**Field-Truthing and Monitoring of the Proposed PennEast Pipeline,  
FERC Draft EIS, Docket No. CP15-558**

September, 2016

Prepared by: Delaware Riverkeeper Network

**Figure 1. Penn East Alignment Drawing 000-03-01-212 Revision D. Illustrating an HDD entry work space within a wetland**

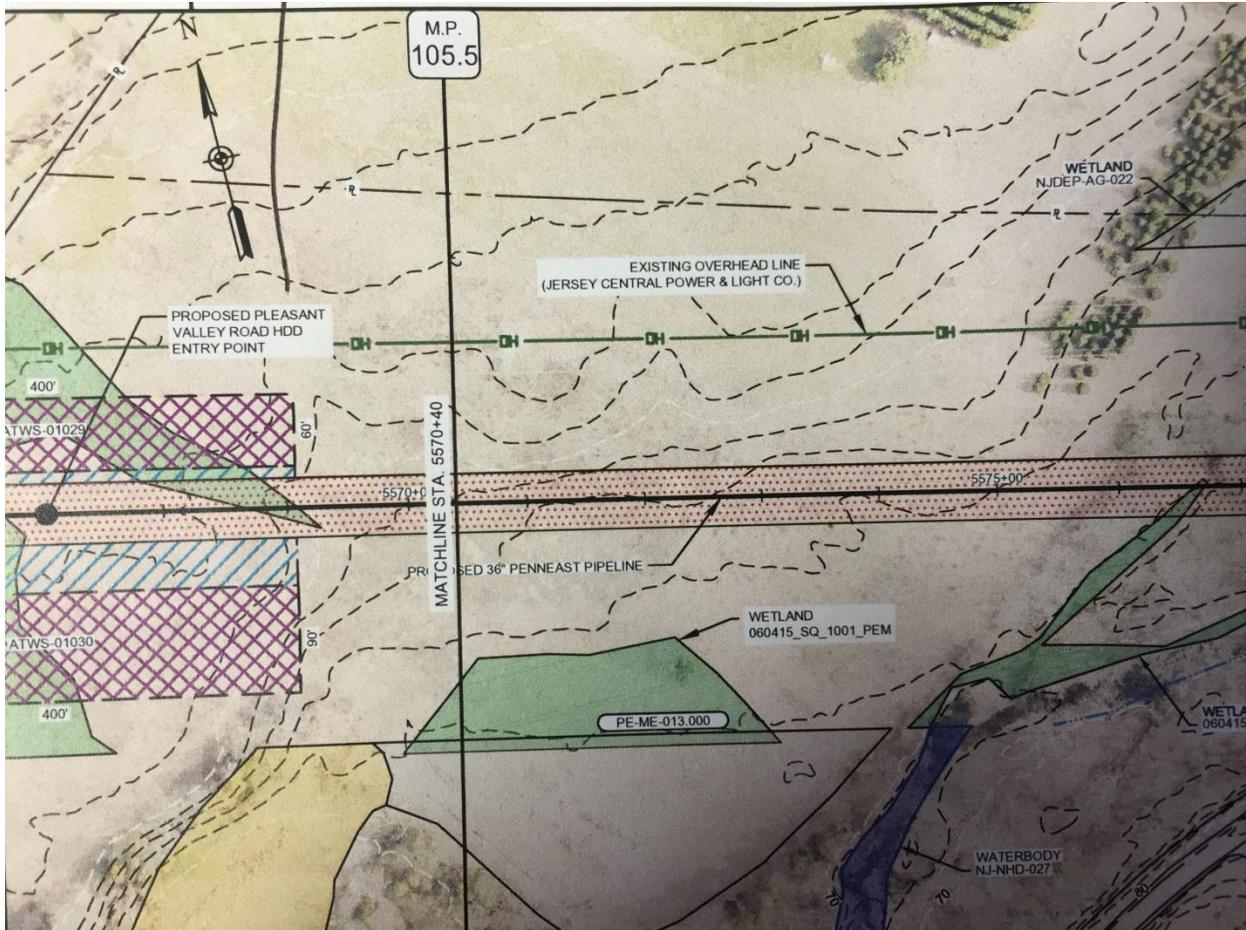
HDD long borings should be considered and analyzed for feasibility for each and every waterbody crossing along the route to reduce impacts to sensitive habitats.<sup>vi</sup> However, in some instances, HDD entrance and exit points which often require large land clearings and impacts to soils are proposed by PE to be located in sensitive wetland and forested habitats. This practice is another indication that avoidance and minimization is not fully being considered for wetlands and waterbodies and the most technological advanced measures and proper citing of HDD are not being considered. For example, in Mercer Co. New Jersey, a horizontal directional drill (HDD) is proposed under Pleasant Valley Rd. and an adjacent stream and wetland complex (between MP 105.5 and 106.0) (see figure 1). However, in this instance, the HDD entry point is proposed to be located at MP 105.4 and within a large PEM wetland complex (1002-PEM and 1001-PEM). According to alignment sheets, that HDD entry point in the wetland would require temporary work space on either side of the permanent ROW in addition to a 400' by 90' and 400' by 60' ATWS on either side of the permanent ROW within the wetland. It would be less impactful to extend the HDD entry point westward away from the waterbody or forest to reduce impacts and to encourage longer HDD borings to better avoid impacts from open cuts.

Figure 2. Penn East Alignment Drawing 000-03-01-213 Revision D. Illustrating an HDD exit work space adjacent a wetland and parallel a stream. Mature trees also appear to possibly located in this reach though faded alignments are provided by PE which make land use determination difficult.

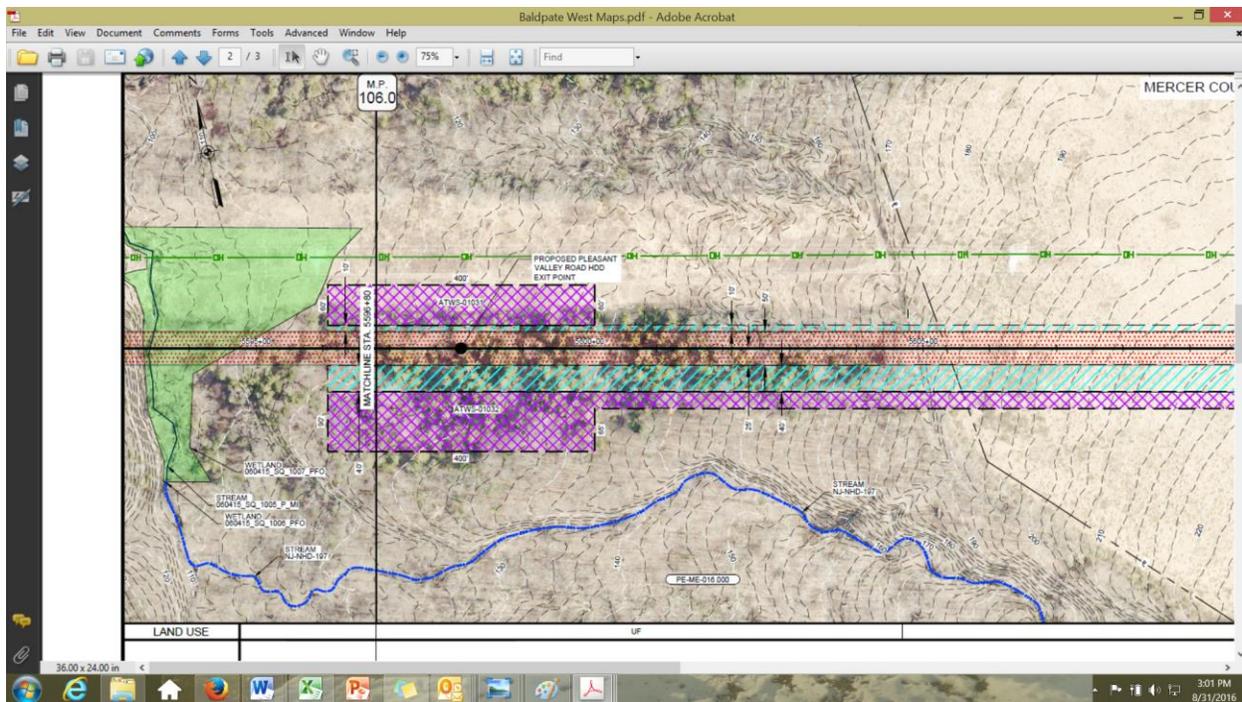
The exit point for this same proposed HDD section is proposed just adjacent another wetland complex and just north of and paralleling a stream (see figure 2). The faded aerial overlays that are provided by Penn East in alignment sheets are unclear but it appears mature trees may be cut for this HDD exit point. Again, it would be less impactful to extend the HDD to a location where already impacted land would not be harmed since technology is feasible to drill for longer segments, thereby reducing impacts. An HDD should be required in this MP area to minimize harm to the point pleasant wetland and stream complex but the citing for the exit and entrance points is inappropriate yet it has been deemed acceptable impact by FERC.

**Figure 3: Vernal pools and groundwater seeps along base of Blue Mountain. Note red line depicts pipeline route with 400 ft. survey area. Herpetologists recommend 1,000 ft buffer of upland to protect vernal pool species.**

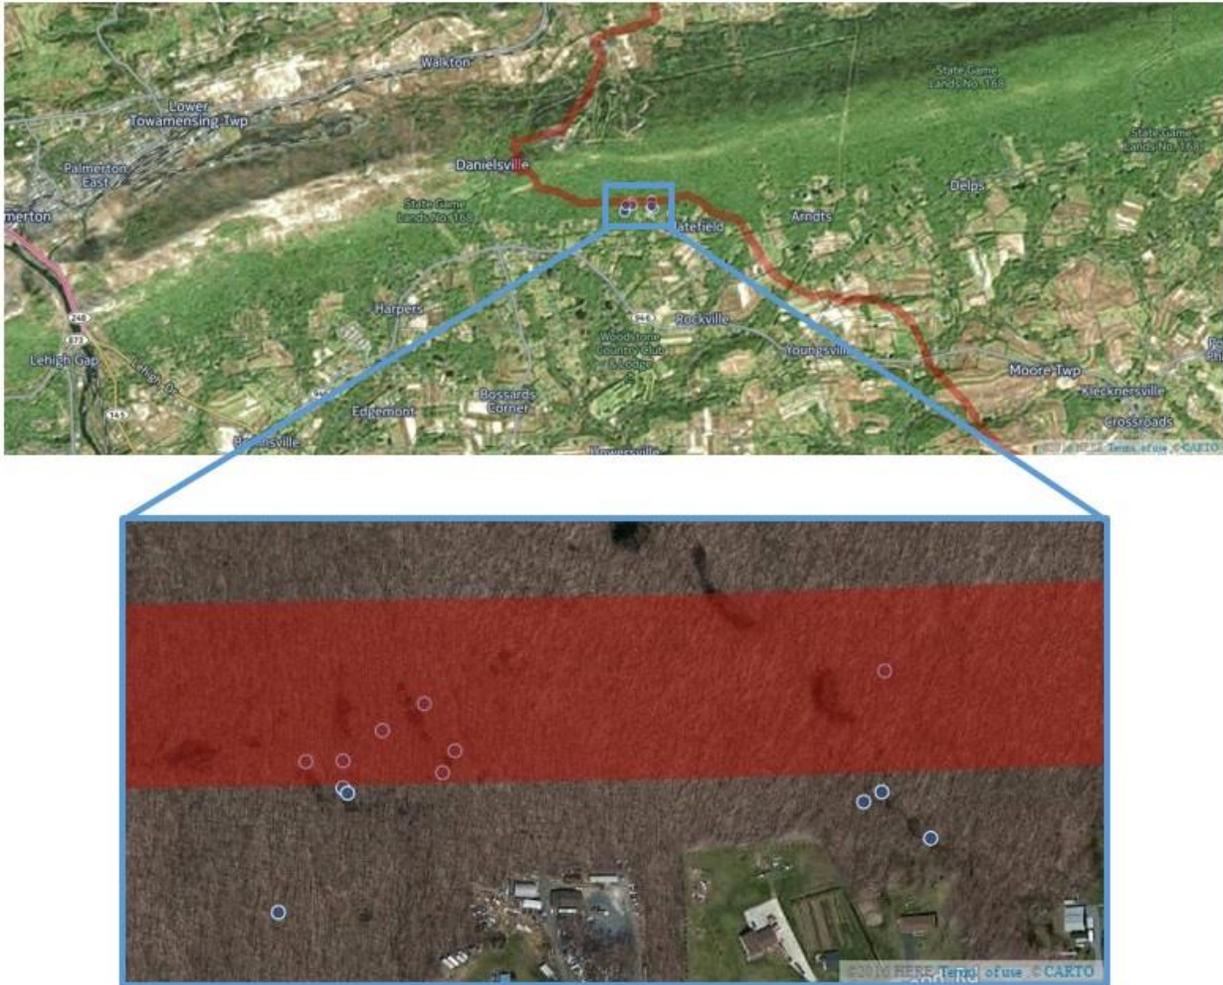
For example, DRN field-truthed and surveyed SGL 168 along MP 52.4 to MP 52.9 on August 28, 2016 after reviewing PE wetland delineation maps (maps not part of the DEIS) and alignment

sheets (Revision D) that showed there were only three vernal pool habitats present in this area of the route. (072415\_JC\_1001\_VP, 072415\_JC\_1003\_VP, 72415\_JC\_1002\_VP on Figure 3 Sheets 129 and 130, PE wetland delineation map). When DRN assessed and walked this section of pipeline, it was clear vernal pool habitats were missed even in areas that PE has noted as being surveyed. DRN documented 12 vernal pools or potential vernal pool complexes and groundwater seeps and depressions that may serve as habitat along this same area of the pipeline route (see Figure 3). Table G-11 of the DEIS notes only two vernal pools in this area at MP 52.4 and MP 52.6 and both are forested yet an open cut (25 feet and 67 feet) is the crossing type PE is proposing. One stream, an UNT to Indian Creek at 52.4 is documented by PE on Table G-7. No groundwater seeps or springs have been documented by PE in this area. This is not protective of the vernal forested pool habitats that obligate and facultative vernal pool species require and it also does not include or map all vernal pools and groundwater seeps that were present in this reach of the proposed route. Table G-11 in the FERC EIS and the wetland delineation maps provided by PE are also not consistent.

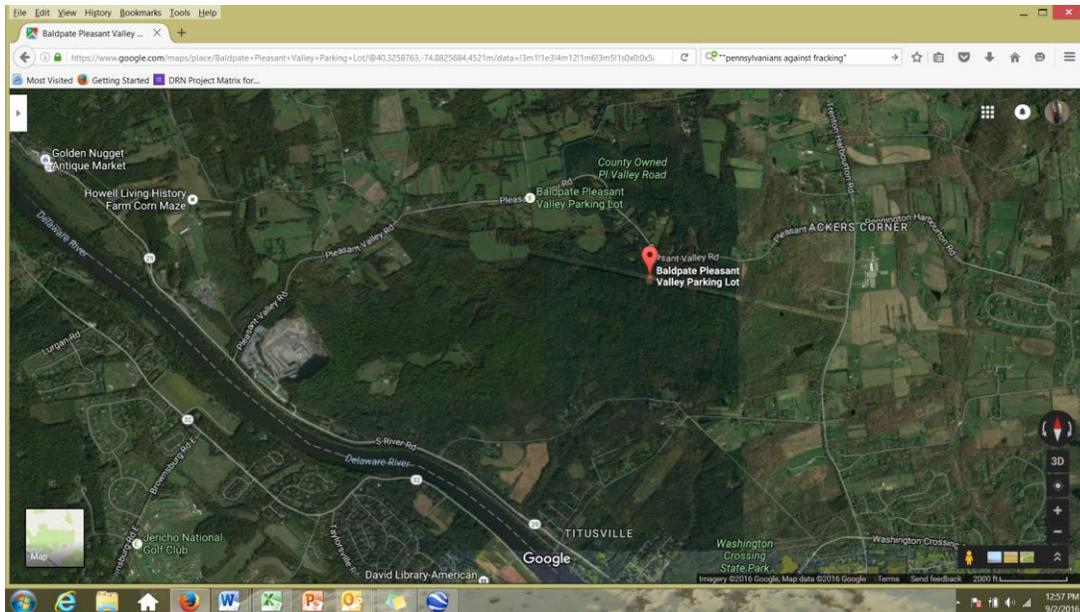
On July 30, 2016, DRN field-truthed a short section of the proposed PE pipeline corridor along Ted Stiles Preserve at Baldpate Mountain in Hopewell Township, New Jersey (MP 107.2 to MP 106.8). DRN walked west from the Baldpate parking area about a half mile just south of the existing electrical ROW.

Figure 13. Approx. location of the intermittent stream within proposed ROW corridor on Ted Stiles Preserve at Baldpate Mountain not mapped by Penn East

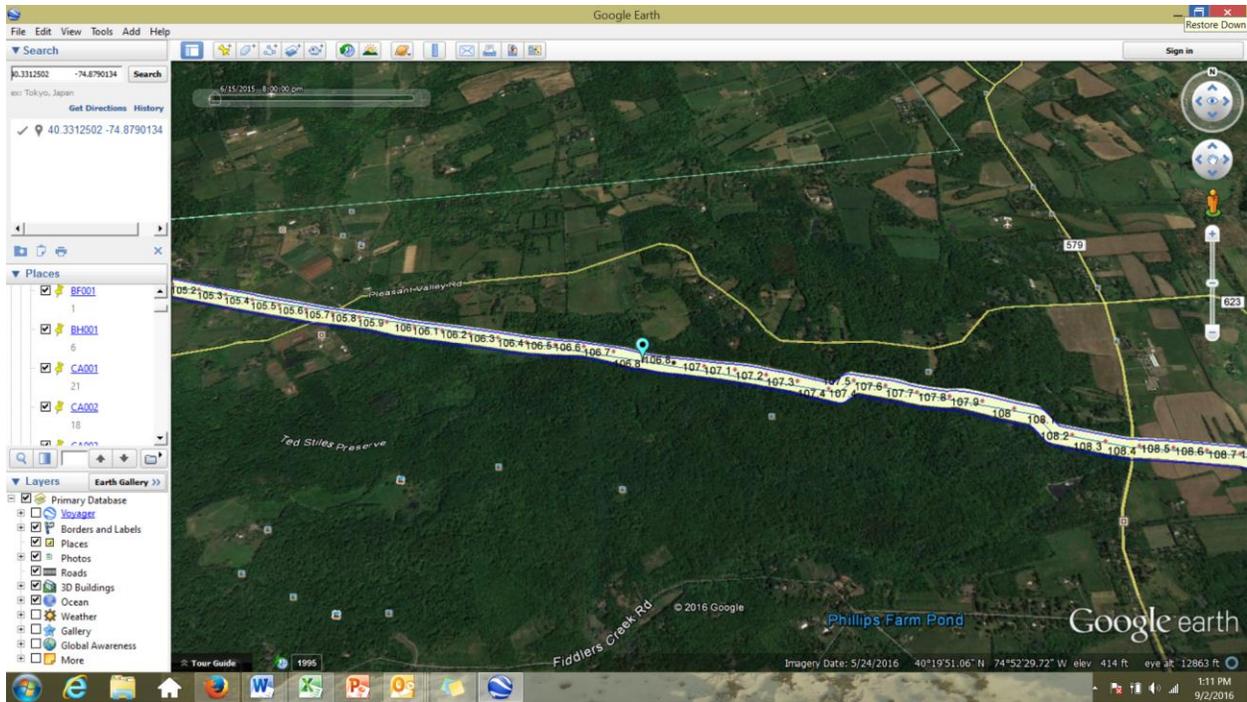
This Mercer County Public Park has over 12 miles of marked trails for hiking, horseback riding, mountain biking, and trail running. According to the DEIS and PE alignment sheets, this area had been surveyed by PE. No flagging was observed during ground-truthing for the pipeline center line, or any of the wetlands or streams along the proposed pipeline route we encountered as late as July 30, 2016. An intermittent stream was not delineated on the PE alignment sheets nor was there flagging present to note this water feature despite the fact that the stream is delineated on state freshwater mapping layers available to the public. Table G-6 in the DEIS also does not list this stream as a waterbody to be cut.

**Figure 18: Wetland delineation maps not part of DEIS package**

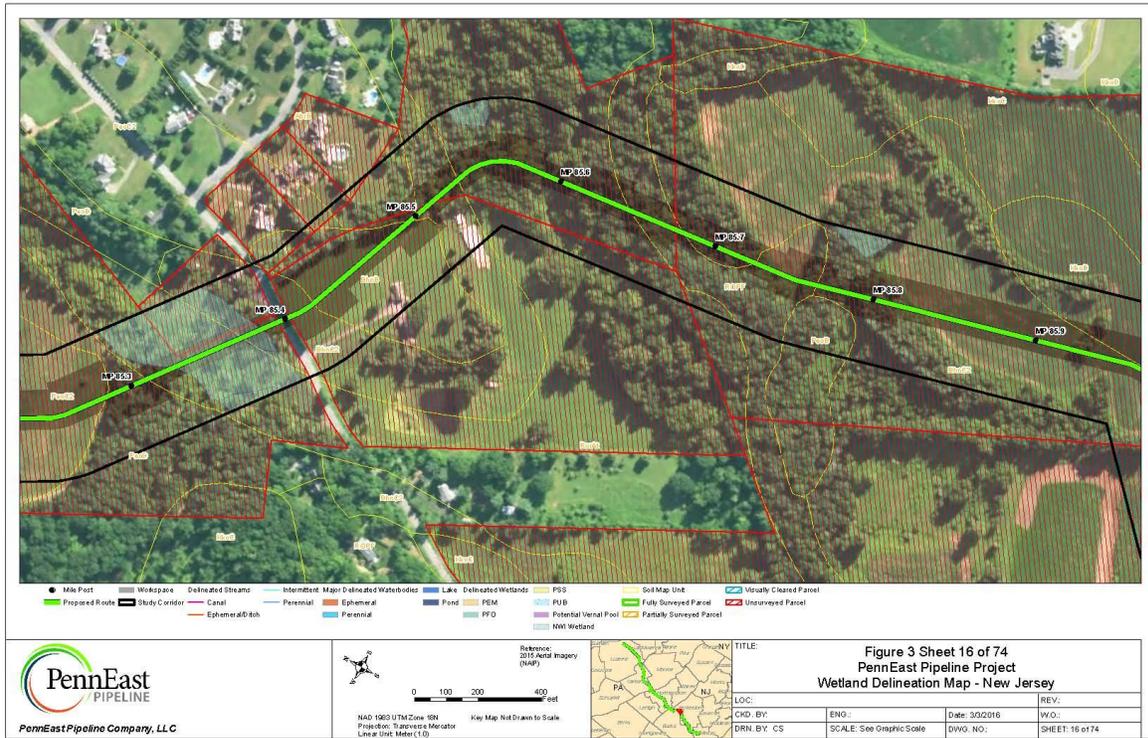
The crossing lengths identified by PE appear inaccurate and photos below indicate more disturbance of PFO depending on the alignment. The DEIS lists for this wetland complex the PFO is only 1 ft., the PSS 227 ft., and the PEM 79 ft. With some mature trees being present in the wetland, a 1 foot PFO estimate does not adequately account for the large trees likely to be cut. But no alignment sheets are updated for this deviation of the pipeline route in the DEIS plus alignment sheets included do not have MPs delineated like earlier versions which makes it difficult to cross reference waterbody crossings with MPs in the field esp. since so much of the areas have not been flagged by PE in the field. Without updated alignments sheets which FERC states only need be provided before construction, field visits and independent reviews cannot easily be provided by the public for a thorough review of ATWS or TWS which may be included at this crossing. Landowners on deviations also do not appear to have access to the alignment sheets at this time either. This inadequacy of mapping in the draft EIS is a gross omission by FERC. The map below is from the wetland delineation report for this wetland and stream (MP 85.3 to MP 85.4) which does not provide detailed construction plans as the alignments do (these maps were obtained from the DRBC website not the DEIS). Note the unsurveyed field parcels here by PE (red hatch). These delineation maps were not part of the DEIS volumes provided by FERC which indicates another missing piece and data source that is not readily accessible nor made available at all to the public and community reviewing the DEIS.

**Figure 21: Temperature Data from UNT to Harihokake Creek that flows through wetland complex**

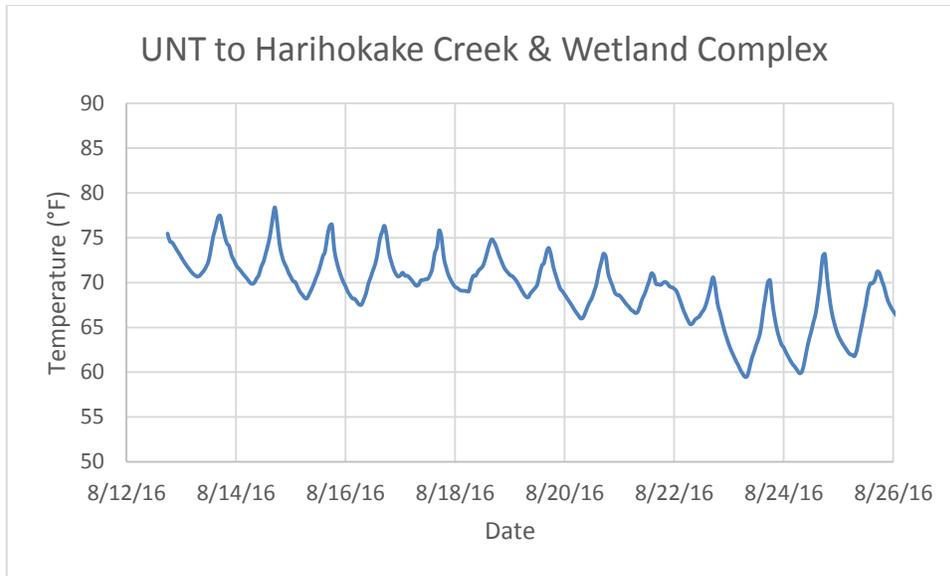
The summer stream temperatures collected from this station on the UNT and wetland are indicative of good water quality, ranging from 59.5°F to 79.0°F, with a mean of 69.4°F. The conductivity of the stream on 8/12/16 was 371 uS/cm. From Aug 27 to Sept 7, 2016 the stream was dry and the HOBO probe was taking air temps as a result (air temps. removed from graph above). These dry conditions indicate the very sensitive nature of these headwater streams and wetland complexes PE proposes to cross. The proposed ROW would cut across this wetland and stream complex bringing with it cascading and long term impacts that would impact stream and wetland temperatures and reduce shading and habitat that is currently present in this wetland complex. The proposed ROW would cross the Harihokake and its tributaries at 7 different locations (MP 85.4, 85.6, 85.8, 85.9, 86, 86.3, 86.7), which poses a threat to this watershed individually and cumulatively. Again, FERC has not assessed the cumulative impact of all of these cuts across watersheds, FERC has not required in situ information or stream water quality conditions to be collected by PE, FERC has not required updated alignment sheets and maps – all gross errors and omissions in the DEIS.

**Figure 23: Temperature data for Alexauken Creek, by ROW**

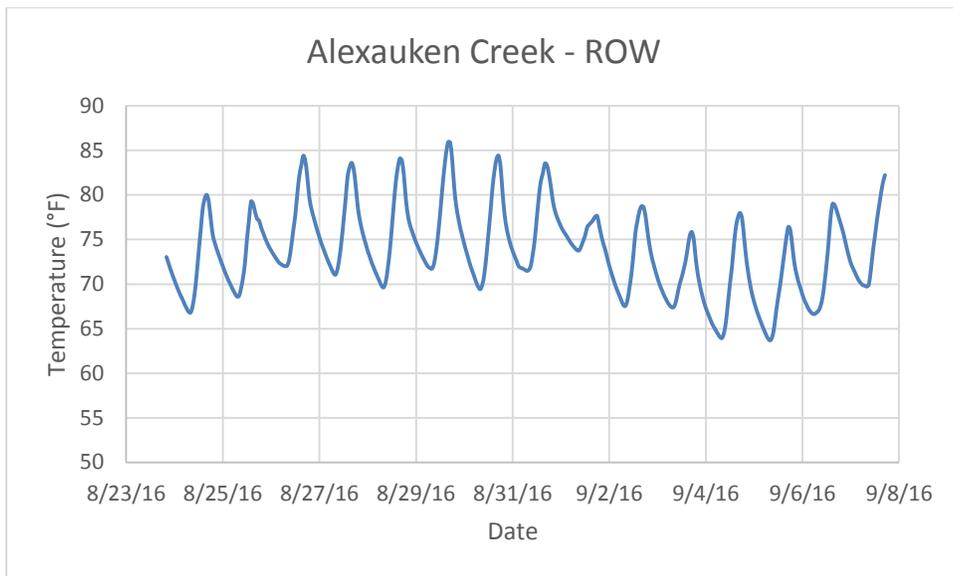
The data from the ROW logging station on the Alexauken show daily fluctuation. The temperatures range from 63.7 °F to 85.9 °F, with a mean of 73.7 °F. Whereas, the data collected from the other non-ROW station show much less fluctuations in temperature. For this station, the temperatures ranged from 66.4 °F to 78.5 °F, with a mean of 72.7 °F. Aquatic species generally have a preferred temperature range, and thrive in more stable temperature conditions. A ROW close to a waterbody means that air temperature would affect water temperature more rapidly. These rapidly fluctuating temperatures can wreak havoc on aquatic life. In comparison, a water body away from ROW and surrounded by forested land, would not be affected by air temperature as much, since the forest would act as a buffer to regulate water temperature. These trends can be clearly seen in the data collected for Alexauken Creek. The station by the ROW not only had a higher mean temperature, a much higher maximum temperature than the other station.

Alexauken Creek is classified as a trout maintenance stream (FW2-TMC1). According to N.J.A.C. 7:9B-1.14(d), the temperature for this stream shall not exceed 25°C (77°C). The temperatures from Alexauken Creek certainly exceeded this standard, which shows that the stream is already impacted (it is an impaired waterbody). With the proposed pipeline ROW, right along these stations (as seen in Figure 1), the degree of impact will be greater, which can prove fatal to the local ecosystem. The proposed PE pipeline would cross the Alexauken and its tributaries 7 times, which poses a threat to the already impacted stream. In a December 2010 report, by Princeton Hydro (in collaboration with the Delaware Riverkeeper Network), Alexauken Creek

**Figure 27: Remaining groundwater seep in the dry UNT to Alexauken Creek. Note dead fish. Over 100 small fish were located in this pool which is directly in the route of the proposed PE pipeline.**

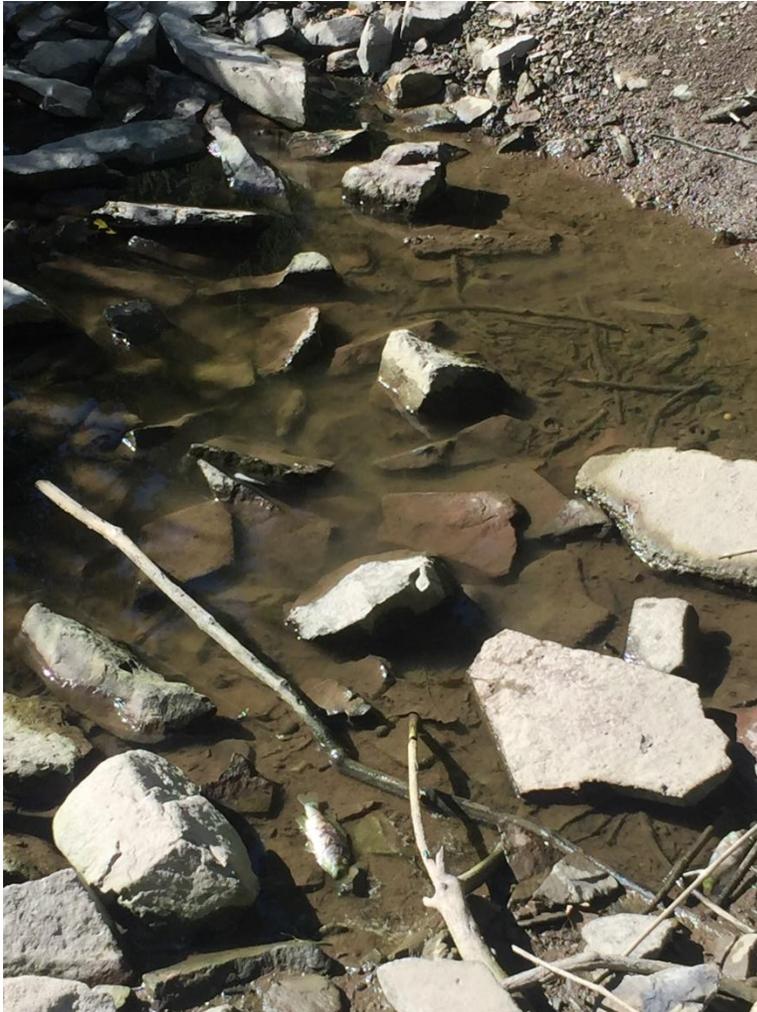
A third temperature logging station was located along an unnamed tributary of Alexauken Creek. This station was located southeast of the downstream Alexauken Creek station. The probe was installed on August 23, 2016. However, on August 28 the unnamed tributary ran dry. During the 5 days the probe was in the water, the temperatures ranged from 63.9°F to 73.0°F, with a mean of 67.0°F. This small tributary is just one of many intermittent streams that are along the proposed PE pipeline ROW. This UNT tributary alone is proposed to be crossed 3 times by the pipeline, which would cause serious harm to an already stressed system and watershed. A picture of the dry streambed observed on Sept 7 below is provided and again these streams that have groundwater seeps within the ROW will be disrupted if another cut is allowed.

Figure 28: April 2016 Map showing increased fragmentation proposed by PE ROW

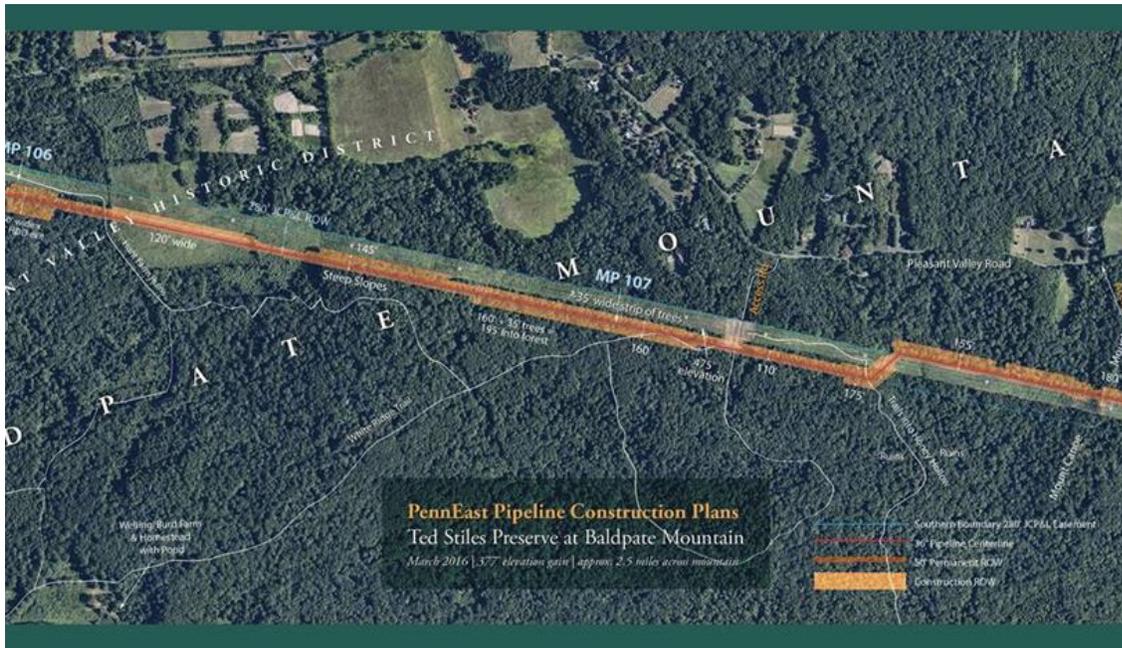
This map below based on April alignment sheets helps illustrate the additional forest fragmentation impacts that are being proposed for a public preserve that has some of the last remaining forest in the region and that already has an existing ROW. The DEIS states that

colocation is less impactful but this is not what the maps document since in the gas line would run adjacent to the existing ROW cutting through new habitat in the Ted Stiles Preserve on Baldpate mountain instead of being built within the current ROW footprint which means more habitat disturbed, trees cut, and an extension of forest fragmentation further into the woods (in the instance above).
